Heaton Primary Accessibility Action Plan

4.1 Action Table						
COSTS – N = NONE		M= MINIMAL	OG = ONGOING MAINTENANCE	ST = STRUCTURAL CHANGE	EX = MAJOR STRUCTUARL CHANGE	
Item Ref.	Details/Issue	Recommendation			Est Cost	Action Taken
PRIORITY A						
2.3	The position of the bays would not allow both bays to be used at the same time	<p>The bays should be repositioned, parallel to one another, to allow both bays to be accessed at all times .</p> <p>The designated accessible parking should be clearly marked out at least 2.4m wide x 4.8m long, plus a side transfer zone at the side and end of the bay.</p> 			M	Only 1 bay is for parking, other is for parent to drop off disabled child.

13.7
cont.

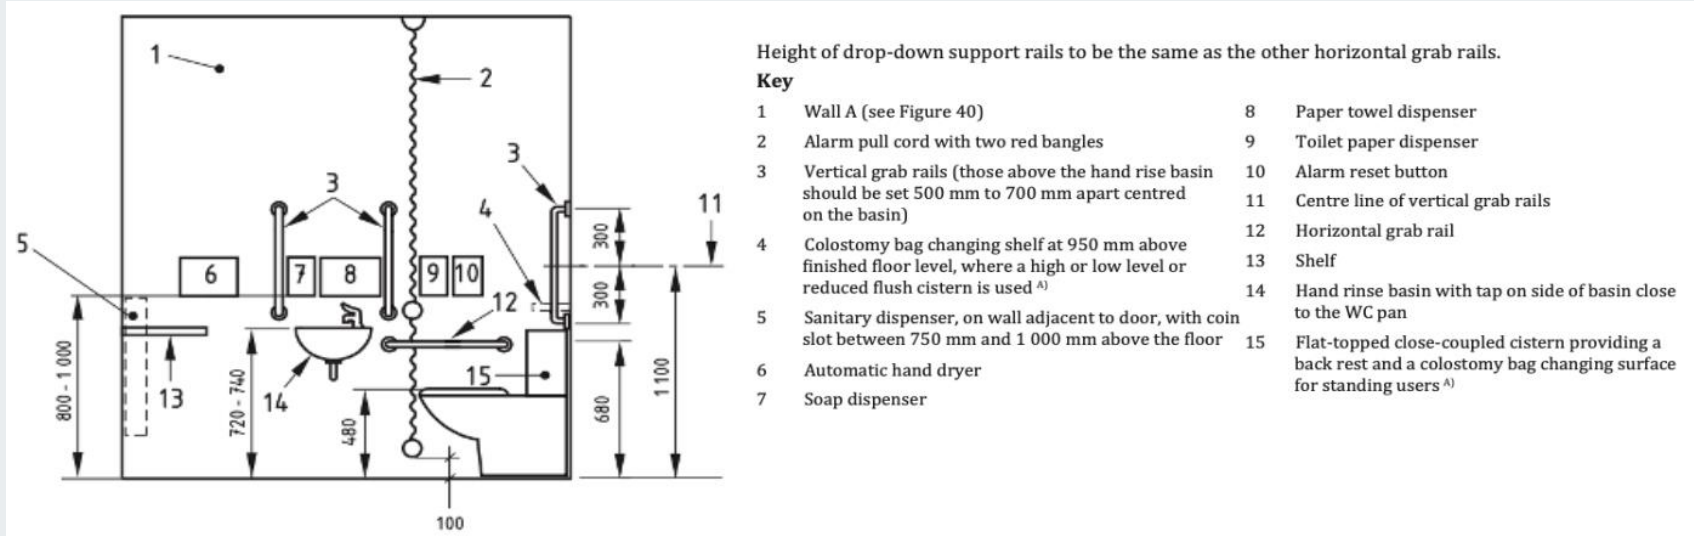
13.7	<p>Compartment 270 (the hygiene room) featured grab rails with minimal colour contrast, and a grab rail was missing to the left of the hand wash basin.</p> <p>A grab rail was missing to the left of the hand wash basin in the facility by years 5 and 6.</p> <p>The facility being refurbished featured grab rails that were not well contrasted to the top half.</p>	<p>The grab rail sets should be replaced with a new BS8300 compliant set that offers colour contrast. Alternatively, a contrasted background could be provided.</p> <p>A difference in LRV (Light Reflectance Value) between rail and background of 30 points is considered reasonable. In accessible WCs a blue rail set on white walls is a common accessible combination.</p> <p>Grab rails should be positioned as shown in BS8300 Figure 42:</p>	M

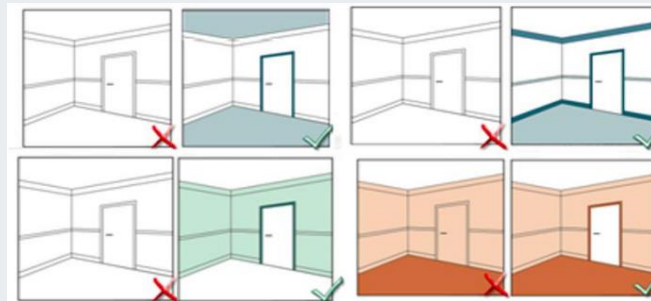
The fire exit doors across KS1 were not well contrasted against the surroundings frames.

The exit door by area 21 was not well contrasted against the surrounding frame.

Ideally all doors should have contrast against the surroundings upon which they are seen. This could be achieved by painting the door frames a contrasting colour. Adding colour contrast will aid people with impaired vision.

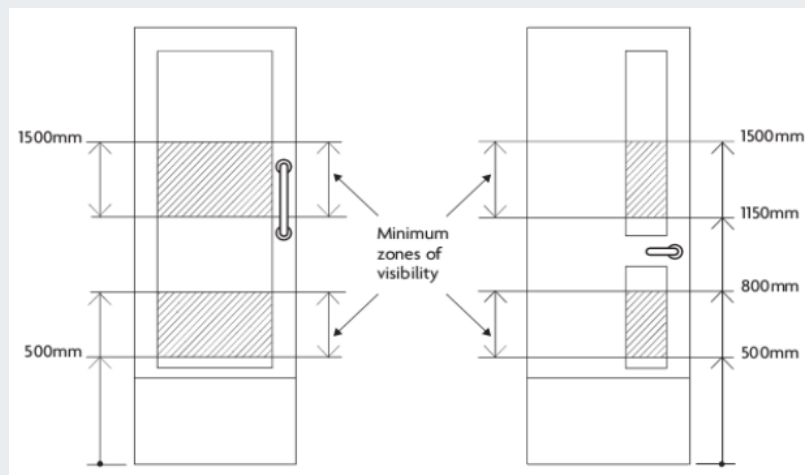
8.3 Most areas of the school featured doors with suitable vision panels. The doors in zone 4 featured high vision panels, which could be a collision hazard for wheelchair users and people who are short in stature.

A rolling refurbishment programme should be implemented to install new BS8300 compliant doors with vision panels to zone 4.

Vision panels need to be included in frequently used doors where privacy (toilets etc.) is not required with a minimum visibility zone between 500mm and 1500mm from floor level and located at the side of the leading edge.

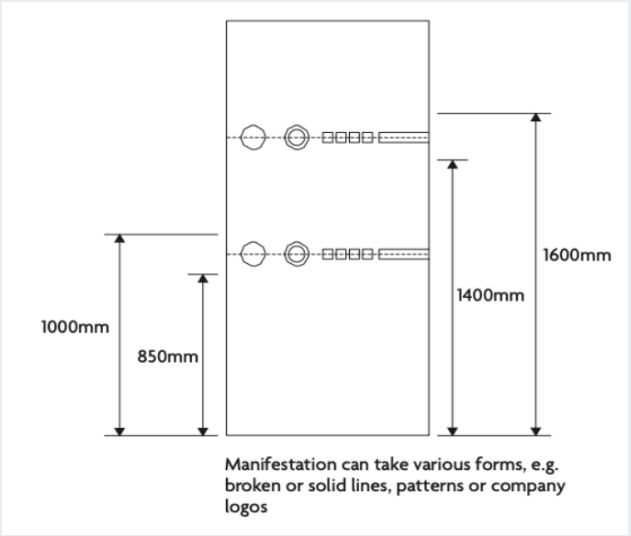
<p>5.9</p>	<p>Not applicable for the main entrance.</p> <p>The double doors leading into entrance near room 42 were glazed with no manifestations and could be a collision hazard.</p>  <p>1000mm 850mm 1400mm 1600mm</p> <p>Manifestation can take various forms, e.g. broken or solid lines, patterns or company logos</p>	<p>All full height glazed areas must be clearly highlighted with manifestation that contrasts visually with the surface behind it under both natural and artificial lighting conditions, from all likely viewing directions. This manifestation should be located within two zones, from 850mm to 1000mm from the floor and from 1400mm to 1600mm from the floor.</p>	<p>M</p>
